RE: Special Use Permit Application (SUP 23-4) Taylor Middle School- Second Round Agency Comments

SUBJECT: Special Use Permit Application (SUP 23-4) Taylor Middle School
Planning 2nd Review Comments

Taylor Middle School Traffic Impact Study (2nd Submittal) Review

Re: **Taylor Middle School TIA & SUP – 2nd Submission**

FIGURE 4-10 COMMERCIAL ENTRANCE DESIGNS ALONG HIGHWAYS WITH CURB AND GUTTER*

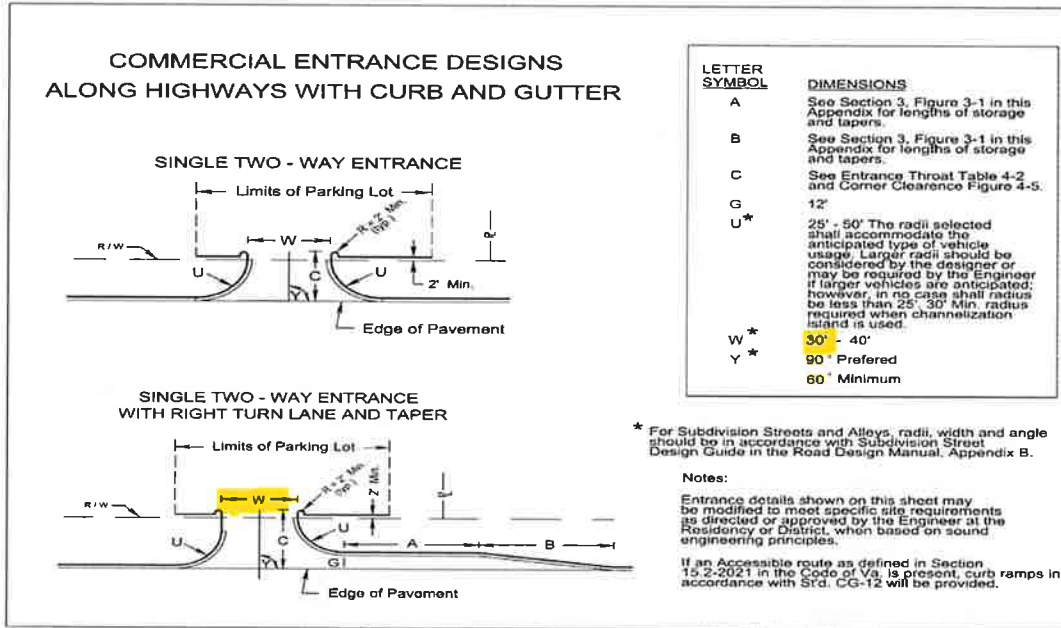
- The current/proposed entrance geometry does not appear to meet VDOT standards. The minimum entrance width is 30'. Since this road is within the Town jurisdiction, VDOT will defer to the Town. VDOT recommends that all proposed entrance radius are confirmed with Autoturn movements.
